Memorandum

Re: East Lake Sammamish Trail November 2017 Segment 2B Shoreline Land Use Hearing

Rebuttal to Charlie Alexander Testimony Delivered on November 20th, 2017

Figure 1 – AASHTO minimum bicyclist operating space compared to a three lane trail cross section.

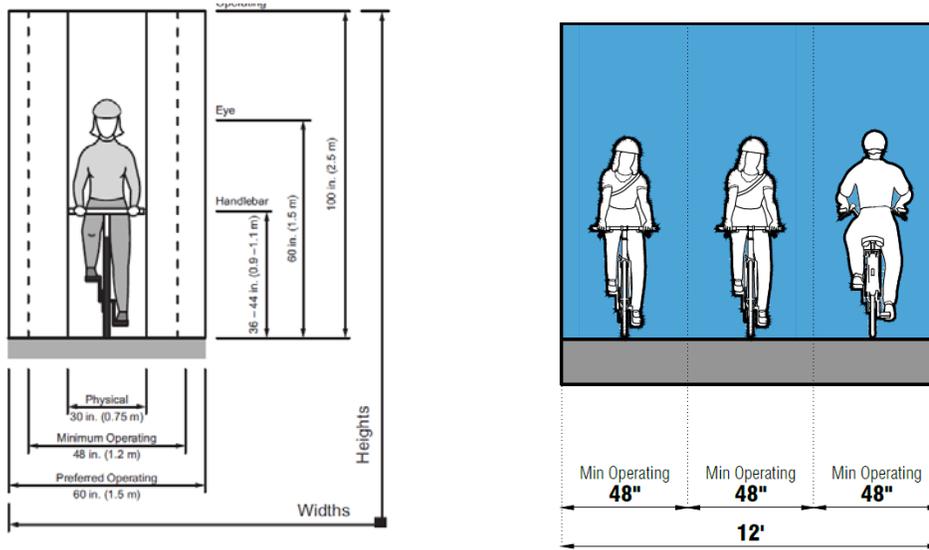
Mr. Alexander has asserted “A context-sensitive design process would conclude that the trail can be narrowed without causing disproportionate safety effects.” He further asserts that the trail can be vary in width between 8 and 12 feet throughout the length of the trail to avoid unspecified physical constraints. Mr. Alexander ignores in his critique and recommendation that it would be acceptable to vary the trail width repeatedly the fact this is a critical major trail link for King County Parks and Recreation connecting the Cities of Redmond, Sammamish and Issaquah. It also directly connects to a major regional park and is being designed to provide a high-quality trail experience for its users. A critical aspect of providing a high-quality experience is to design a trail that allows for sociability – namely the ability of people to walk side by side or bicycle side by side. Any experienced trail designer realizes that is how people want to experience a trail and that is how most people attempt to use a trail unless they are traveling alone. People traveling side by side take up more space, thus the potential for conflict increases as trail volumes increase. The purpose of a wider trail isn’t to necessarily allow bicyclists to operate at an “optimum speed” but to provide enough space for bicyclists to able to pass people walking without creating a safety problem or passing so close as to degrade the pedestrian experience or a collision. Figure 1 shows the AASHTO minimum operating space envelope with a representation of a 12 foot trail functioning as three lanes which is what is intended for high volume trail facilities.

Repeatedly changing the dimensions of the trail will not conform to user expectations of this trail to provide a “high quality experience” and has the potential to result in trail users being surprised by repeated instances of trail narrowing whereupon they collide with another trail user or ride off the path and potentially crash as their “lane” is removed. The trail facility should be thought of as providing “lanes of travel” for users and thus a core decision is whether this trail should function as a two-lane facility where users travel in single file, or if it can be designed as a three-lane facility where many users will have the ability to travel side by side. The minimum desirable width based on operating space is a 12-foot width. While the AASHTO Guide states an 11 foot trail can allow for 3-lane operation, it is clear that this requires the user operating space to be encroached upon or for users to ride at the very edge of the trail which could increase their risk of leaving the trail in crowded conditions. Mr. Alexander appears to be trying

to apply roadway design thinking to his assessment where lane widths may vary. Roadways are not designed however to constantly add or remove through lanes along the main alignment where consistent volumes are present as this would create safety problems.
